**TSG-RAN Meeting #12
Stockholm, Sweden, 12 - 15 June 2001**

TSGRP#12(01) 0393

Title: Agreed CRs to TS 25.415

Title:	⌘ Immediate Rate Control clarification		
Source:	⌘ R-WG3		
Work item code:	⌘ TrFO	Date:	⌘ 2001-05-15
Category:	⌘ F	Release:	⌘ Rel-4
	<p>Use <u>one</u> of the following categories:</p> <p>F (essential correction) A (corresponds to a correction in an earlier release) B (Addition of feature), C (Functional modification of feature) D (Editorial modification)</p> <p>Detailed explanations of the above categories can be found in 3GPP TR 21.900.</p>	<p>Use <u>one</u> of the following releases:</p> <p>2 (GSM Phase 2) R96 (Release 1996) R97 (Release 1997) R98 (Release 1998) R99 (Release 1999) REL-4 (Release 4) REL-5 (Release 5)</p>

Figure 11: Successful Rate Control

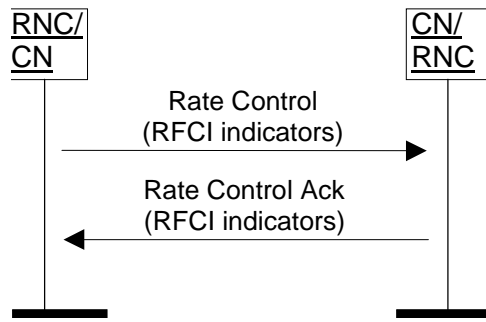
Reason for change:	⌘ This CR clarifies the reasons why rate control shall be issued immediately by the target RNC after detection of relocation execution trigger and gives the proposed behaviour of the CN, similar to the description of the behaviour of the CN on receipt of RELOCATION DETECT, where "... the CN may switch the user plane from the source RNC to the target RNC." The difference is that - given through the split cs CN architecture in Rel-4 – switching the user plane on RELOCATION DETECT will in most cases cause too much delay. Additionally, a typo has been corrected.
Summary of change:	⌘ Clarification on the concept behind the immediate rate control procedure (after relocation).
Consequences if not approved:	⌘ The concept behind the immediate rate control procedure (after relocation) might be misunderstood and cause incomplete implementations.

The procedure can be signalled at any time when transfer of user data is not suspended by another control procedure. When the user plane was initiated due to SRNS relocation reasons no rate control shall be signalled before the reception of the relocation execution trigger. At the reception of the relocation execution trigger the RNC shall start the rate control procedure. This enables both TrFO partners to exchange current maximum rates and proceed user data transport based on latest rate decisions. Further, the reception of the first rate control frame from the target RNC, which indicates the CN the successful relocation execution on user plane level, should cause the CN to switch the user plane from the source RNC to the target RNC.

- The NAS data streams specific functions forward to the upper layers the complete protocol data in a Iu-UP-Status indication primitive;
- Upon reception of the Iu-UP-Status request primitive, the procedure control functions shall acknowledge the Rate Control including maximum rate control information. If the entity receiving the rate control frame is not the TrFO partner, it shall not acknowledge the rate control frame.

Figure 9: Successful Initialisation of Iu UP for m RFCIs

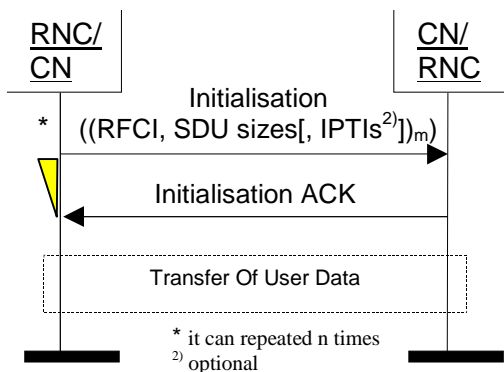
Reason for change:	⌘ The procedure text for initialisation needs to be clarified since it is not obvious from the current text that receipt of a new INIT frame replaces the current RFCI information for both the uplink and downlink direction. The term “relocation execution trigger” refers to text in RANAP, and it is proposed to add the RANAP reference after the term. It is not clear from the specification that Rate Control commands shall always be acknowledged and that the own Rate Control information shall be returned in the acknowledgement frame. The indication of the frame payload part (right most part) in figure 25a is wrong, (this mistake was also present in the initial CR that introduced TrFO).
Summary of change:	⌘ Clarify that receipt of a new INIT frame can replace the current stored RFCI information. Clarify that when the receiver acknowledges a Rate Control frame then the own maximum rate control information is included. Add a RANAP reference after the term “relocation execution trigger”. Correct figure 25a.

The invoking entity allocates a RAB sub-Flow Combination indicator (RFCI) to each RAB sub-Flow Combination it initialises. The association of indicators to RAB Flow Combinations is valid for both the uplink and downlink direction in the Iu UP until a new initialisation procedure is performed or the connection is terminated.

Upon reception of a frame indicating that an initialisation control procedure is active in the peer Iu UP entity, the Iu UP protocol layer forwards the whole protocol information contained in the initialisation frame to the upper layers. It also stores the RAB sub-Flow Combination set (and thus replaces a possible previous set) in order to control during the transfer of user data, that the Iu UP payload is correctly formatted (e.g. RFCI matches the expected Iu UP frame payload total length). The peer Iu UP entity receiving the initialisation message shall choose a version that it supports and for which it has enough initialisation information.

Figure 11: Successful Rate Control

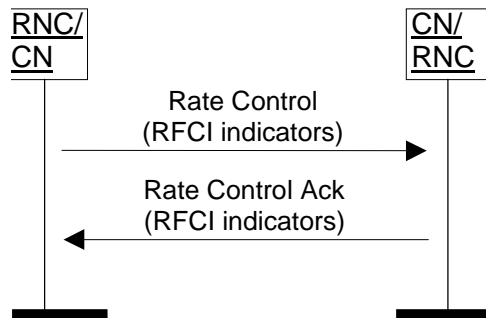
The procedure can be signalled at any time when transfer of user data is not suspended by another control procedure. When the user plane was initiated due to SRNS relocation reasons no rate control shall be signalled before the reception of the relocation execution trigger [\(see \[3\]\)](#). At the reception of the relocation execution trigger the RNC shall start the rate control procedure.

The Procedure control function upon request of upper layer prepares the Rate control frame payload containing the maximum rate of the reverse direction of the rate control frame. To align the Rate Control procedure with version 1 of the Iu UP protocol the permitted maximum rate is given as a set of RFCI indicators, that shall contain the maximum rate and all rates below the maximum rate, i.e. all rate controllable and non rate controllable rates. In the context of TrFO and TFO the Rate Control procedure may also be controlled by a [remove-remote](#) peer.

- The NAS data streams specific functions forward to the upper layers the complete protocol data in a Iu-UP-Status indication primitive;
- Upon reception of the Iu-UP-Status request primitive, the procedure control functions shall acknowledge the Rate Control [by including its own](#) maximum rate control information. ~~If the entity receiving the rate control frame is not the TrFO partner, it shall not acknowledge the rate control frame.~~
